FUTURE INTELLIGENCE TECHNOLOGY SINGAPORE PTE. LTD.

Declaration of Product Modifications

This is to request a Class II permissive change for FCC ID: 2BUEC-VI-R01 originally granted on 04/02/2026.

Internal Photos	
Original EUT	New EUT

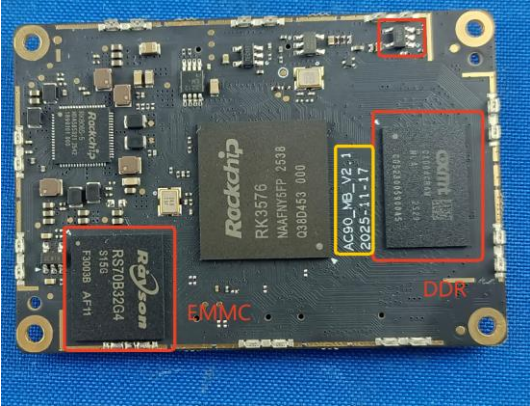
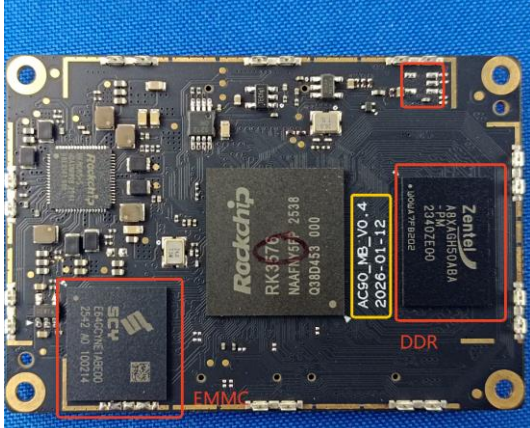
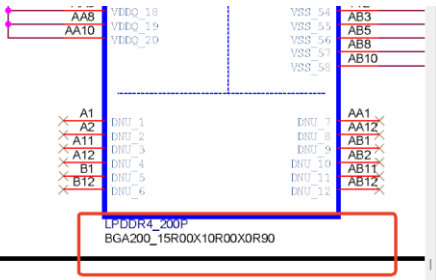
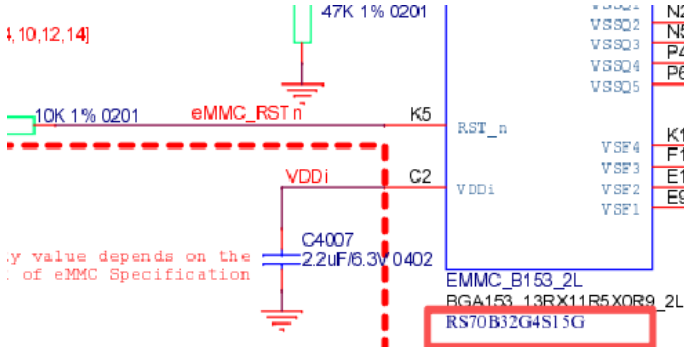
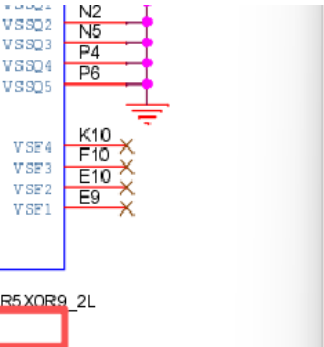
Updated the second supply DDR, EMMC and Remove the power supply for the camera zoom motor(Disable the power supply for the camera zoom motor. It was originally set up as a backup, but now it has been removed. This does not affect the functionality.) , And updated the internal photos. After evaluation, tests were conducted on Emissions in frequency bands (below 1GHz) item. The original test data is not affected.

SCH	
Original	
DDR  	
EMMC

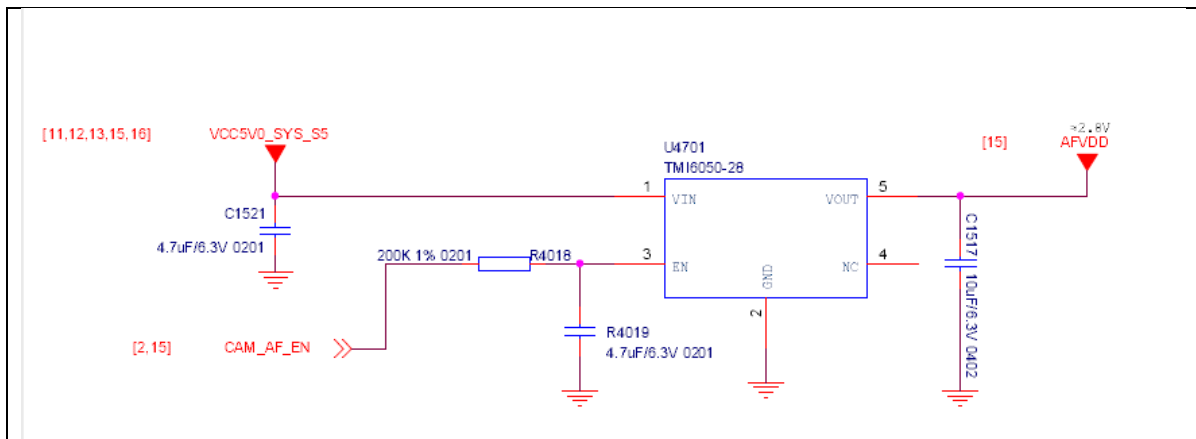
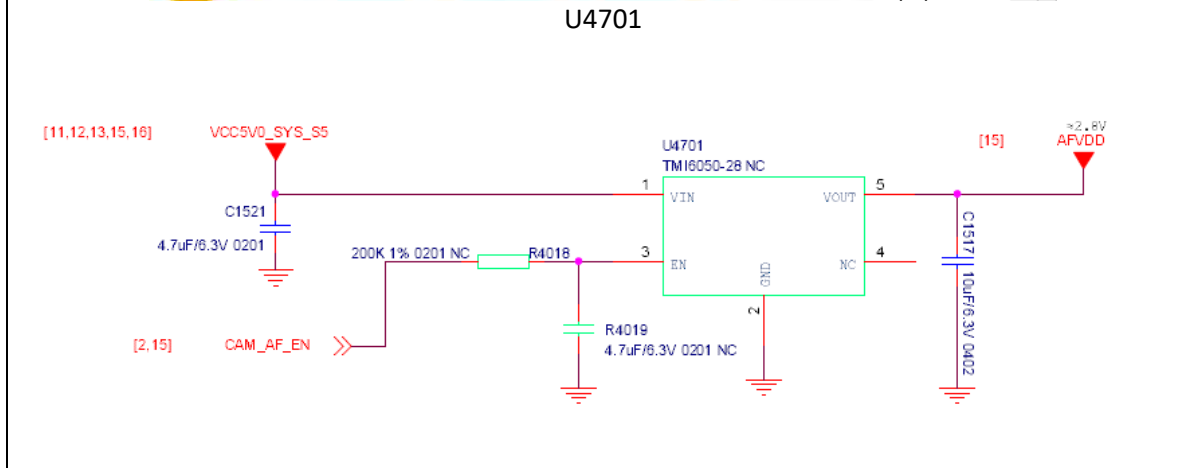
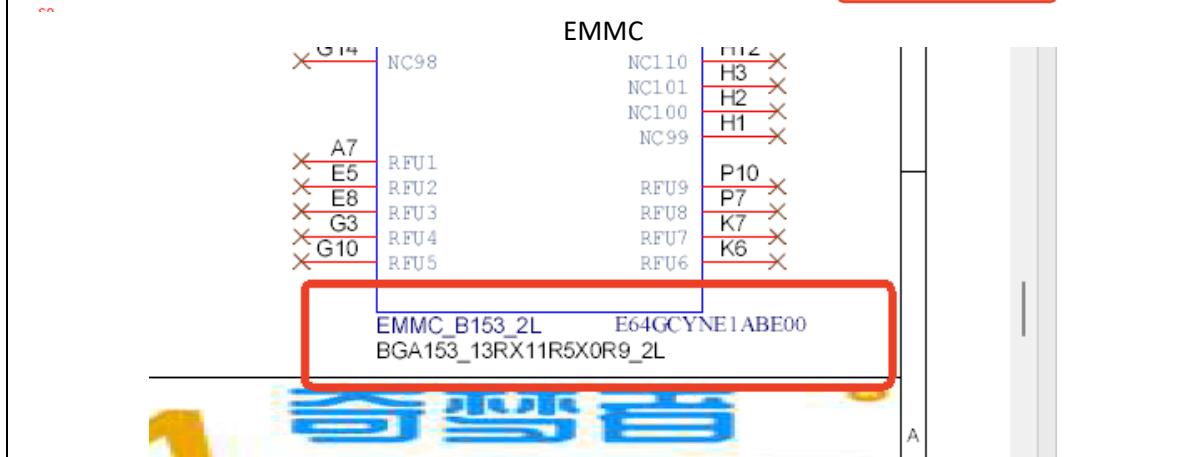
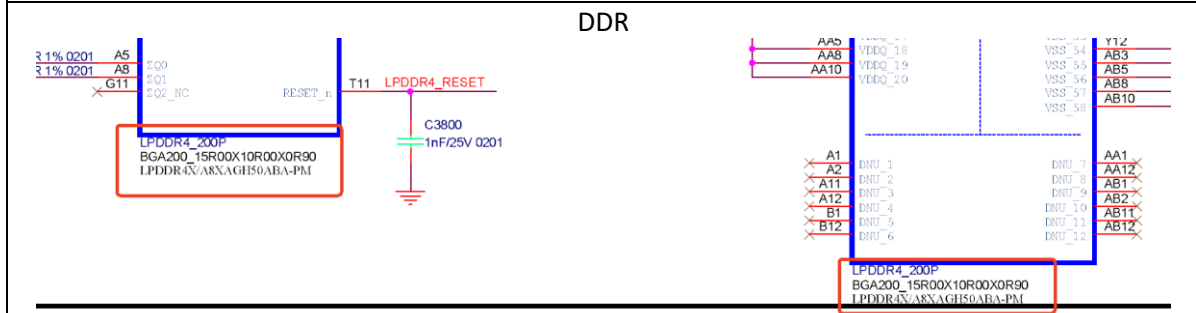
U4701

New
